**Alabama State Port Authority**  
**Addendum to R&P or Specification Booklet**

**Project Name** 2022 Marine Liquid Bulk Terminal Dock Fire System Refurbishment

**Project No.** 11041 **Task No.** 02 **Addendum No.** 1

TITLE				
FIBER OPTIC ROUTING TO "MTF" CONTROL ROOM				
SCALE	DRAWN BY	DATE	SHEET	24x36 REV.
AS NOTED	RCC	01/05/22	_____ of _____	B
JOB NO.	CHECKED BY	DATE	DRAWING NUMBER	
4017-22	JJM	01/05/22	4017-E3

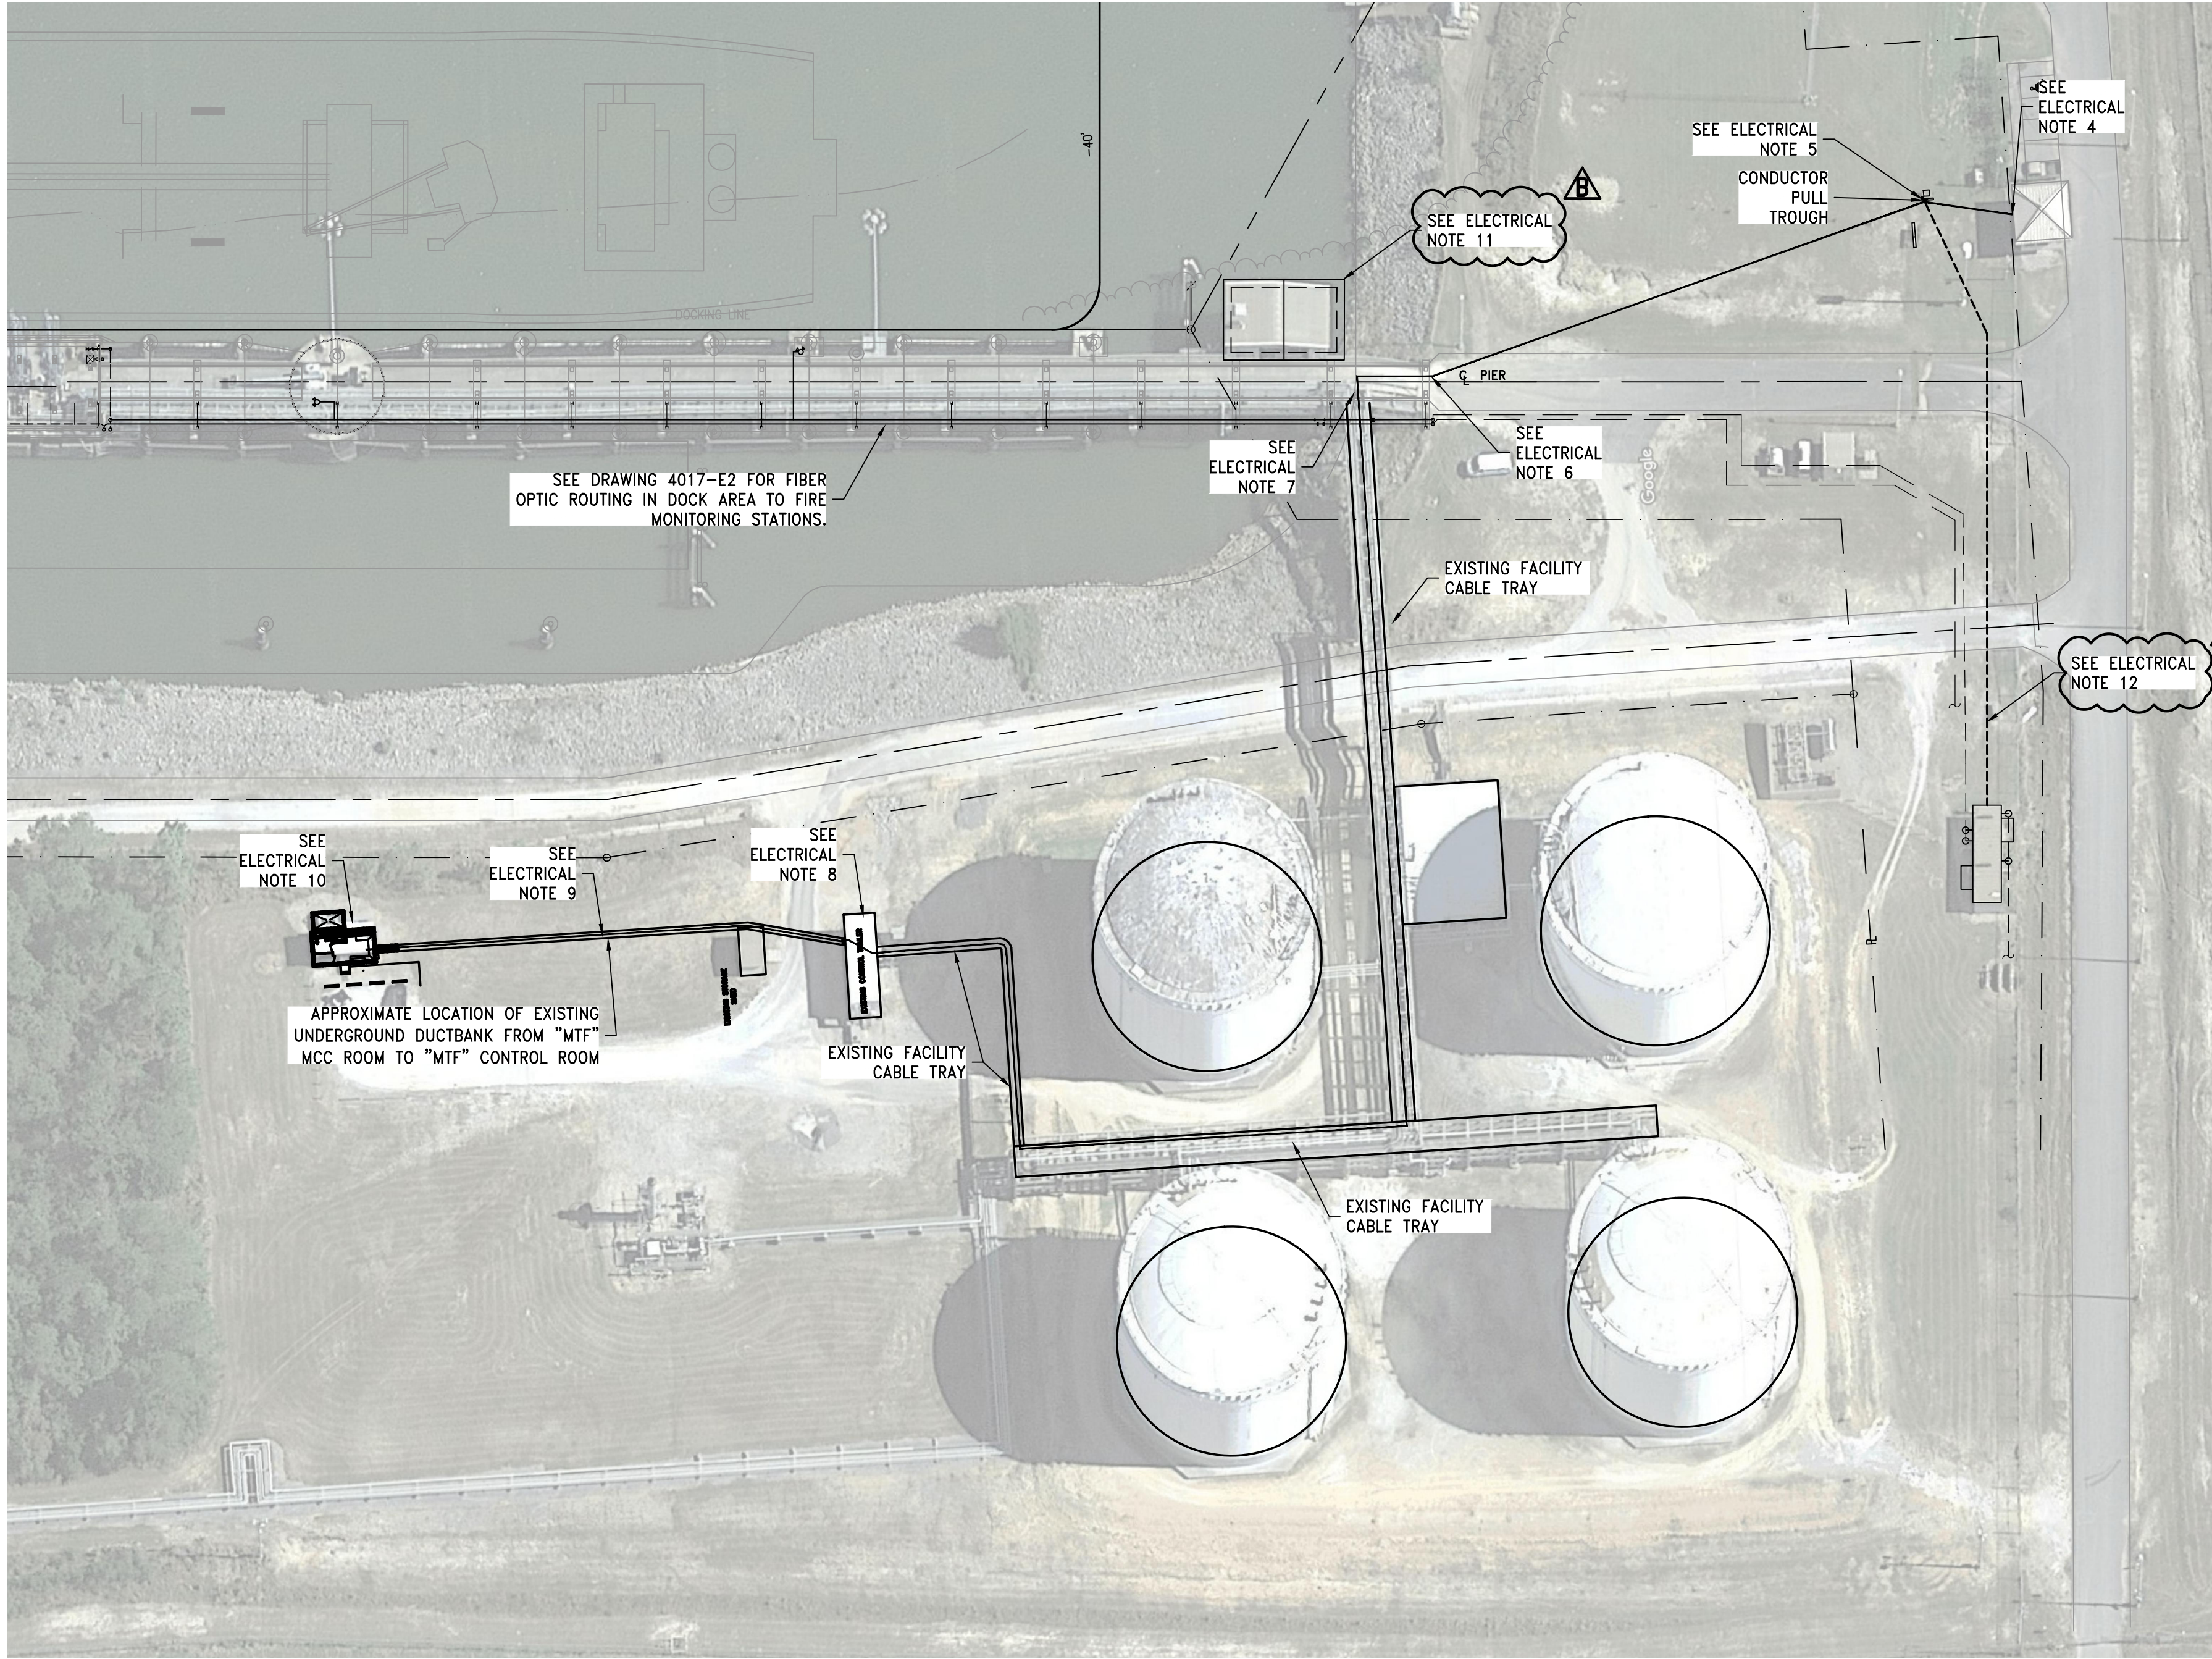
17.	<p>Question: Are any additional signs beyond NFPA required signs to be provided?</p> <p>Answer: No</p>
18.	<p>Question: Will fire alarm be required on this project?</p> <p>Answer: Yes, the intent is to have a panel in the pre-pac house, the boat house and report to guard shack and INEOS. Additionally a horn strobe on the outside of the guard shack is requested for notification. DWG.4017-GA3 Rev B is attached and is hereby incorporated into the bid documents by this addendum</p>

21.	<p>Question: How can we get fiber from the pre-pac house to the guard shack?</p> <p>Answer: Contractor will be required to install a 2" conduit from the pre-pac house to the guard shack in order to route fiber. DWG.4017-GA3 Rev B is attached and is hereby incorporated into the bid documents by this addendum.</p>

- 12. CONTRACTOR SHALL ROUTE THE FIBER OPTIC THROUGH A NEW 2"ØC UNDERGROUND CONDUIT FROM THE PREPACKAGED FIRE PUMP SYSTEM TO THE PULL TROUGH LOCATED JUST NORTH OF THE GUARD HOUSE AND LEAVE SLACK FOR INTERFACE TO THE NEW ALARM MONITOR STATION TO BE LOCATED IN THE GUARD HOUSE.
